ARTICLE INFORMATION ON OVERRUNNING ALTERNATOR PULLEY 55627

TECHNICAL INFO NO. 1005

Dacia, Renault

Fig. 2: Overrunning Alternator Pulley RUVILLE 55627

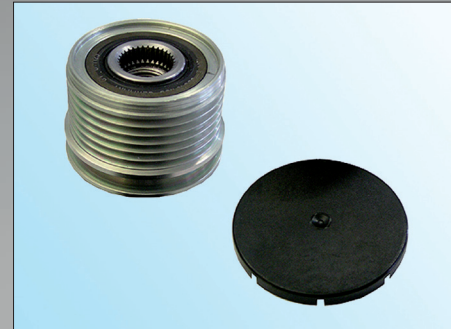
Should the alternator belt pulley be defective (OE ref. 77 00 110 616), it is to be replaced by an overrunning alternator pulley. The overrunning alternator pulley is available with RUVILLE No. 55627.
